DEPARTMENT OF ENERGY**Federal Energy Regulatory
Commission****18 CFR Part 40**

[Docket Nos. RM12-6-000 and RM12-7-000; Order No. 773]

**Revisions to Electric Reliability
Organization Definition of Bulk Electric
System and Rules of Procedure****AGENCY:** Federal Energy Regulatory
Commission.**ACTION:** Final rule.

Figure 1
Two Radial Systems Eligible for Exclusion E1

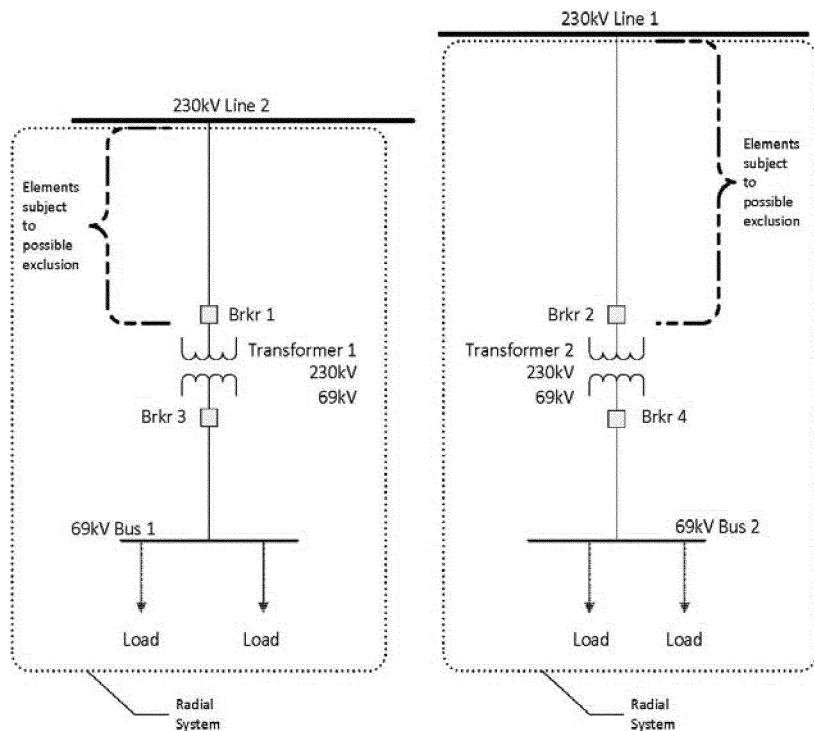
135. NERC and other commenters state that both radial systems depicted in figure 1 would be subject to exclusion E1(a) because they each only serve load.¹²⁶ ELCON agrees with NERC adding that these types of radial systems pose no reliability risk to the interconnected transmission network if the system is lost due to a fault condition. Similarly, SoCal Edison states that the figure 1 facilities would either be excluded or not part of the bulk electric system. SoCal Edison asserts that, because transformers 1 and 2 each have secondary voltages that are less than 100 kV, they do not meet the inclusion I1 requirements and, thus, are not included in the bulk electric system. In other words, SoCal Edison believes exclusion E1 should exclude all radial facilities that are greater than 100 kV up to the point where "the system is no longer radial, as indicated in figure 1 by the brackets where the 230 kV lines meet [lines 1 and 2]."¹²⁷ APPA believes that all the scenarios described by the Commission could create reliability concerns "if taken in isolation and operated in a certain matter" and

136. Anaheim agrees that the radials shown in figure 1 should be excluded and requests clarification that the associated bus work and protection system equipment installed on those radial lines are also excluded. Anaheim advocates that the exclusion should also apply to protection system equipment on the excluded facilities that provide backup protection for devices that are part of the bulk electric system, i.e. lines 1 and 2 in figure 1.

140. The Commission agrees with NERC that the radial systems shown in figure 1 meet the definition of “radial system” in exclusion E1. This configuration would result in the 230 kV lines between transformers 1 and 2 to the two 230 kV lines, respectfully, being excluded from the bulk electric system. The Commission agrees with NERC and other commenters that both radial systems depicted in figure 1 would be subject to exclusion E1 condition (a) because they each only serve load.

Figure 2
Networked Configuration w/115 kV Loop

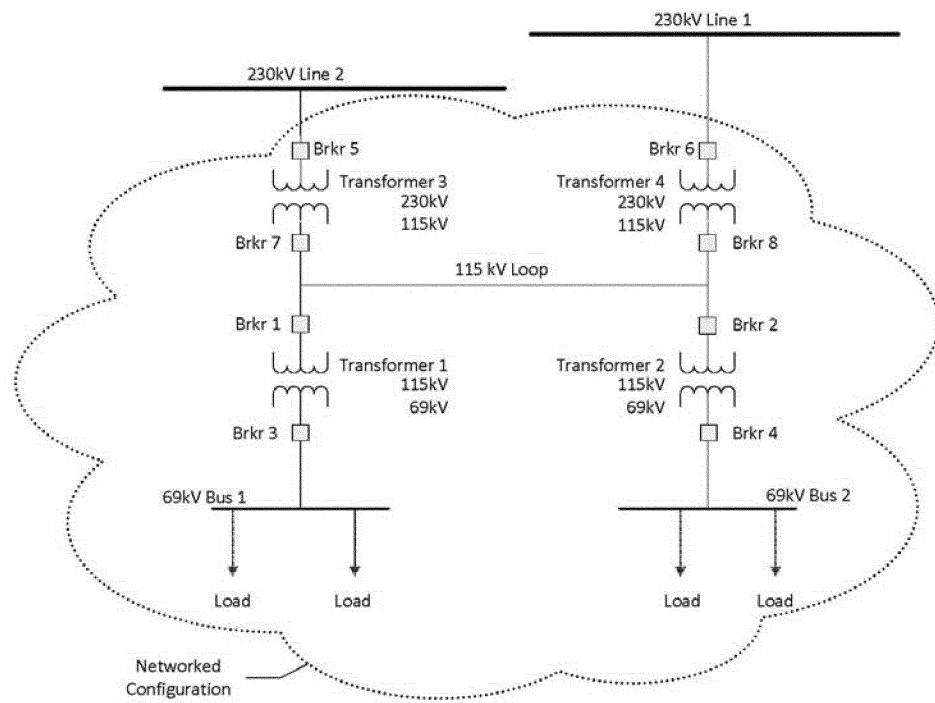
144. In the NOPR, the Commission requested comment on the scenario shown in figure 2 which shows a 115 kV loop, with the configuration emanating from two points of connection of 100 kV or higher. Specifically, the Commission requested comment on whether “the 115 kV and 230 kV elements above Transformers 1 and 2 to the points of connection to the two 230 kV lines would be excluded from the bulk electric system pursuant to exclusion E1.”¹³⁰ The Commission asked for comment on whether it is more appropriate to analyze figure 2 pursuant to the “local network” exclusion E3 and, if so, what if any elements operated at or above 100 kV would be excluded pursuant to exclusion E3.

145. NERC states that figure 2 is a non-radial loop on the 115 kV system. According to NERC, the 115 kV elements above transformers 1 and 2 to the point of interconnection with lines 1 and 2 would not be eligible for exclusion E1 because they do not emanate from a single point of connection. NERC also states that it would be appropriate to evaluate figure 2 under exclusion E3 as a potential local network.¹³¹ For such a candidate local network to qualify for exclusion, NERC states that additional technical analysis is needed to determine if all the exclusion E3 criteria are satisfied.¹³² NERC asserts that without such a technical analysis, the 115 kV elements above transformers 1 and 2 should be considered part of the bulk electric system.

146. Likewise, Idaho Power, ITC Companies, and National Grid contend that the figure 2 configuration should be included in the bulk electric system. Southern Companies believe exclusion E1 may apply from the breakers down and that the configuration may belong to

exclusion E3. AEP assumes that each of the facilities below the 115 kV loop shown in figure 2, and including breaker 1 and breaker 2, are radial and excluded pursuant to exclusion E1. According to AEP, the facilities above breakers 1 and 2 may be excluded pursuant to exclusion E3 depending on the circumstances.¹³³

147. Valero states that the figure 2 configuration is very similar to common facilities configurations employed in many industrial facilities involving the interconnection of the industrial facility to the utility through two high voltage feeder lines that originate at different utility owned and operated substations. Valero requests that the Commission include in the final rule an additional exclusion that would “categorically exclude from the [bulk electric system] any on-site high voltage switchyard facilities (less than 300 kV) owned by the industrial end-user where the predominant function of the facilities is to distribute electricity in an inward direction to the end-user’s load.”¹³⁴ WPPC argues that figure 2 shows both radial and network systems and that the system from the 115 kV loop upwards would be assessed under exclusion E3

148. The Commission affirms NERC’s statement that figure 2 is a non-radial loop and thus would not be eligible for exclusion E1 because it does not emanate from a single point of connection. The Commission agrees with commenters that the elements below the 115 kV loop should be assessed as two separate radial systems pursuant to exclusion E1. The remaining elements (the 115 kV loop, transformers 3 and 4 and the 230 kV tie lines above the transformers to the two 230 lines 1 and 2) should be assessed pursuant to exclusion E3 and if the configuration meets the criteria of exclusion E3, the elements could be excluded.

Figure 3
Networked Configuration w/69 kV Loop

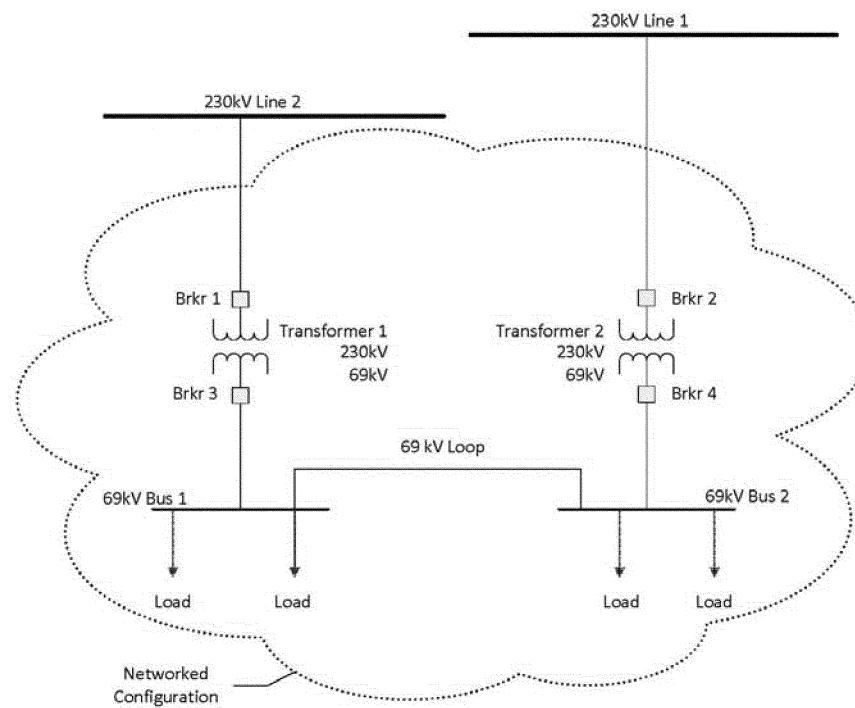
151. NERC disagrees with the Commission's characterization of figure 3 in the NOPR. NERC states that figure 3 does not depict a configuration with two points of 100 kV or higher or a system emanating from two points of connection at 230 kV. According to NERC, except for lines 1 and 2, all the other elements depicted in figure 3 are excluded from the bulk electric system. NERC explains that the elements between line 1 and transformer 2 and from line 2 to transformer 1 are excluded by exclusion E1(a) because "each separate set of [e]lements [described above] is contiguous and emanate from a single point of connection of 100 kV or higher."¹³⁷

153. Exelon agrees with NERC and explains that it has many connections similar to the one shown in figure 3 and provides a specific example where a 138 kV substation is fed by two radially connected 138 kV lines which in turn are connected through 40 MVA transformers to a 12 kV bus section. Exelon states that in its example the 40 MVA transformers cross bus sections so that if one of the 138 kV lines is out of service, each side of the 12 kV bus retains service. Exelon believes that due to the high impedance of the transformers, little energy flows between the buses in Exelon's

154. Other commenters believe that the figure 3 configuration may not be eligible for exclusion E1. SoCal Edison explains that the 69 kV loop is not open and therefore is a parallel path to the 230 kV system. BPA, Alameda and WREA do not view the figure 3 system as eligible for exclusion E1 because the system is networked. Idaho Power states that the 230 kV lines would be included only if there is a protection system in place for the 230 kV lines. According to Idaho Power, the elements above the transformers in figure 3 would not be excluded from the bulk electric system. Idaho Power believes this configuration should be evaluated under exclusion E3.

155. The Commission finds figure 3, which is identical to figure 5, is a networked configuration through a 69 kV loop and does not qualify for exclusion E1. The Commission also finds that, because the load in figure 3 can be served by either 230 kV line, it does not depict a “radial system.” However, the facilities below 100 kV may or may not be necessary for the operation of the interconnected transmission network, and this decision can be made case-by-case in the exception process. In other words, such facilities below 100 kV depicted in figure 3 would be excluded under the general threshold of the core definition unless found on a case-specific basis as necessary for the reliable operation of the interconnected transmission network. Thus, the Commission, while disagreeing with NERC’s interpretation, does not propose to include the below 100 kV elements in figure 3 in the bulk electric system, unless determined otherwise in the exception process. Further, as we discuss below in connection with exclusion E3 and figure 5, while we find that the configuration shown in figures 3 and 5 would not be eligible for exclusion E1, we believe that such configurations should be eligible for exclusion E3 for local networks. However, exclusion E3 as written requires the candidate local network to be contiguous and above 100 kV, thus, the exclusion E3 language as written does not allow for figures 3 and 5 to be eligible for the local network exclusion

because they are not contiguous and include facilities that are not above 100 kV. Therefore, we direct NERC to modify exclusion E3 to remove the 100 kV minimum operating voltage in the local network definition. This modification will enable configurations similar to figures 3 and 5 to be assessed for the local network exclusion. The Commission believes this modification, together with satisfying the criteria outlined in exclusion E3, will appropriately exclude local network configurations that are not necessary to the reliable operation of the interconnected transmission network.¹³⁹

Figure 5
Networked Configuration w/69 kV Loop

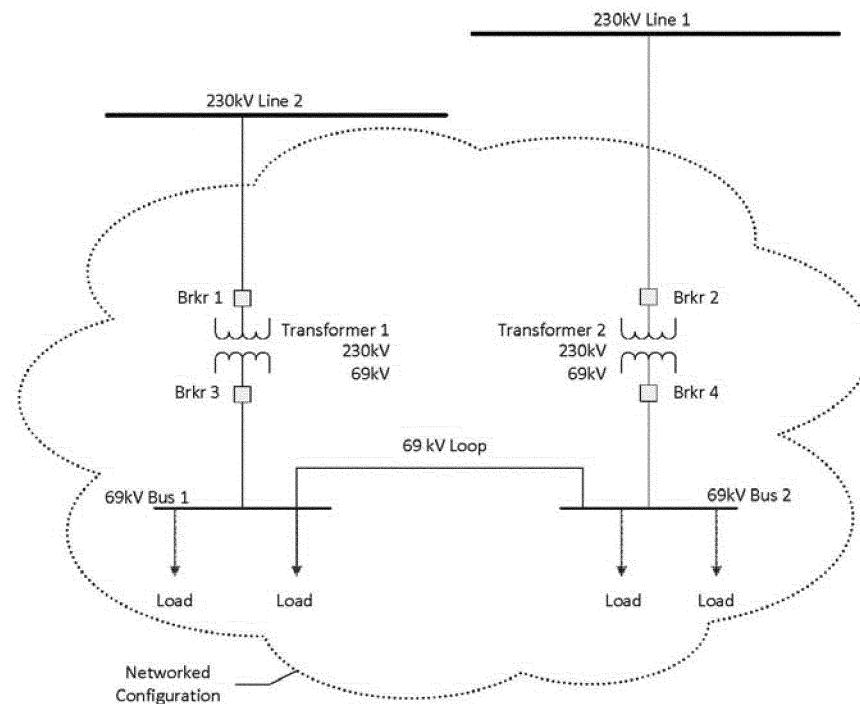
195. In the NOPR, the Commission stated that figure 5 depicts a group of elements that are contiguous through a 69 kV loop and requested comment whether the configuration in figure 5 qualifies as a local network and, in particular, whether the configuration satisfies the conditions that a local network be contiguous and operated at or above 100 kV.

196. NERC views figure 5 the same as figure 3—as a looped system below 100 kV—that is not considered under this exclusion because the elements below 100 kV are presumed to be not part of the bulk electric system.¹⁶⁷ NERC maintains that, if it is determined that the sub-100 kV looped system is necessary for the reliable operation of the interconnected transmission network, the exception process may be utilized to include the appropriate elements. NERC states that figure 5 depicts two separate and distinct groups of elements that each emanate from a

197. Exelon states that the clear intent of the definition is that configurations such as shown in figure 5 are radial systems subject to exclusion E1 (radial systems). According to Exelon, had this not been the intent of exclusion E1, exclusion E3 would have allowed for a local network where the tie was below 100 kV to avoid a reliability gap. Exelon believes that the configuration shown in figure 5, which is identical to figure 3, does not qualify as a local network within the terms of exclusion E3 and supports NERC's view that figure 5 represents two radial systems that qualify under exclusion E1. Exelon cautions that, if the Commission determines that the systems depicted in figure 5 do not qualify under exclusion E1 because of the low voltage tie and does not qualify under exclusion E3 because the tie is at low voltage and not a 100 kV or above, such a decision would leave a gap under which a substantial number of facilities that are not part of the bulk electric system

would be classified as such. Exelon states that it would have to go through the separate exception process for dozens of substations, at great cost and for no useful purpose. Exelon states that the Commission should clarify that the configuration shown in figures 3 and 5 qualifies as a radial system and is excluded pursuant to exclusion E1.

199. As discussed above, the Commission is directing a modification to exclusion E3 to better capture local networks like those depicted in figure 5. The Commission notes that Exelon believes that the configuration shown in figure 5, which is identical to figure 3, does not qualify as a local network within the terms of exclusion E3. While figures 3 and 5 are a networked configuration through a 69 kV loop, they do not qualify for the local network

exclusion because exclusion E3 defines local networks as “[a] group of contiguous transmission Elements operated at or above 100 kV but less than 300 kV that distribute power to Load rather than transfer bulk-power across the interconnected system.” The configuration in figure 5 includes elements that are below 100 kV, and does not have contiguous elements operating at or above 100 kV but less than 300 kV. As noted above, while the Commission finds that these configurations should not be eligible for exclusion E1, we believe that they should be eligible for the local network exclusion. Therefore, we direct NERC to modify exclusion E3 to remove the 100 kV minimum operating voltage in the local network definition. Within 30 days of the effective date of this Final Rule, we direct NERC to submit a schedule outlining how and when it will make the modification to the definition.
